## PIC18(L)F24/25K42 Silicon Errata and Data Sheet Clarification

The PIC18(L)F24/25K42 devices that you have received conform functionally to the current Device Data Sheet (DS40001869E), except for the anomalies described in this document.

The following typographic corrections and clarifications are to be noted for the latest version of the device data sheet (DS40001869E):

Figure 44-5 Clock Timing

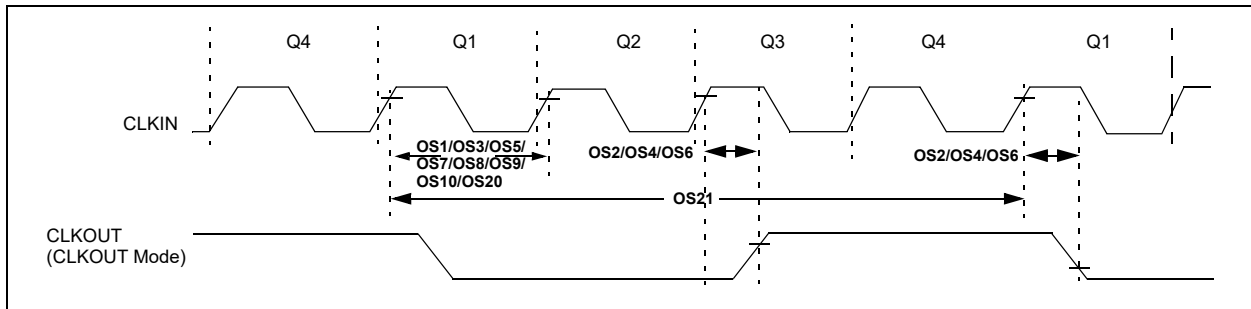
Figure 44-5 incorrectly shows the location of parameters OS1, OS2, OS3, OS4, OS5, OS6, OS7, OS8, OS9, OS10, OS20 and OS21. The correct location for the above-mentioned parameters is depicted in the following figure.
